Re: 2-60 Cumberland Street, The Rocks (SSD 10384)

Northrop Consulting Engineers Pty Ltd, as the stormwater engineering consultant for this project, has reviewed the “Request for Advice” provided by City of Sydney dated 17th December 2020 and provide the following response in relation to item 6- Public Domain-MUSIC link.

Figure 1: MUSIC model layout

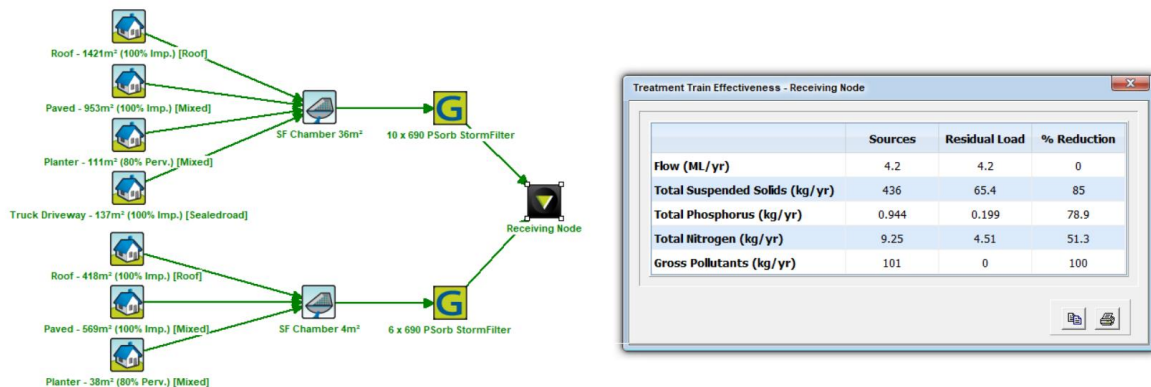
The City has adopted MUSIC-link for assessing Water Sensitive Urban Design (WSUD) compliance for developments. A stormwater quality assessment for the proposed development must comply with the City’s specific modelling parameters as adopted in MUSIC-link. A certificate or report from MUSIC-link and the electronic copy of the MUSIC Model must be submitted for review and approval with the stormwater quality assessment report.

Northrop has assessment the Water Sensitive Urban Design (WSUD) for this project and has proposed the following treatment measures to achieve City of Sydney’s water quality targets. Provided below is a screenshot of the MUSIC model and results.

- 2 x Water Quality Chambers
- Ocean Protect 16x 690 PSorb filter cartridges

As shown above, the stormwater treatment targets appropriate for the site will be met by the treatment measures provided. The pollutant removal performance as predicted by MUSIC modelling exceeded City of Sydney Water quality targets of 90%/85%/65%/45% for GP, TSS, TP and TN respectively.
